Document for ALKS for low speed application (based on the Chair proposal ACSF-23-02-r4)

The Commission would like to thank the chair for the proposal for ALKS in ACSF-23-02-r4 as lastly revised.

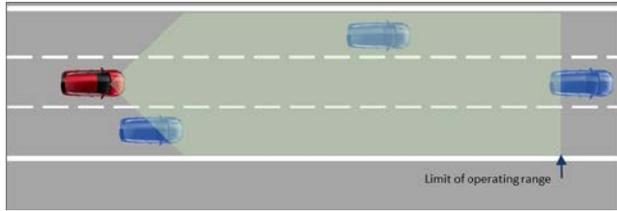
During the transition phase and the minimum risk manoeuver, the system shall instruct the driver in an intuitive and unambiguous way to take over manual control of the vehicle. The instruction shall include a pictorial information showing hands and the steering control and may be accompanied by additional explanatory text or warning symbols, as shown in the example below.
